## PIC32MX534/564/664/764 Family Silicon Errata and Data Sheet Clarification

The PIC32MX534/564/664/764 family devices that you have received conform functionally to the current Device Data Sheet (DS61156G), except for the anomalies described in this document.

**Note:** This document summarizes all silicon errata issues from all revisions of silicon, previous as well as current. Only the issues indicated in the last column of [Table 2](#) apply to the current silicon revision (**A1**).

FIGURE 1: EXTERNAL COMPARATOR SCHEMATIC EXAMPLE

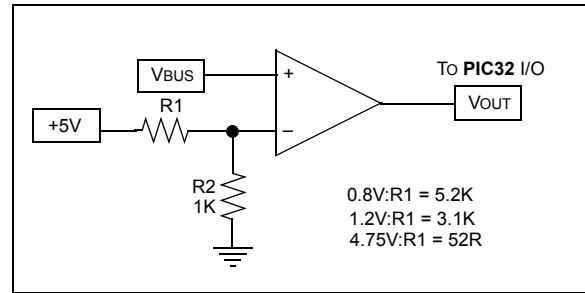
When the USB model is configured for OTG operation, it may not properly recognize all required OTG voltage levels on VBUS pin.

Use external comparator circuit to detect OTG specific voltage levels on VBUS pin.
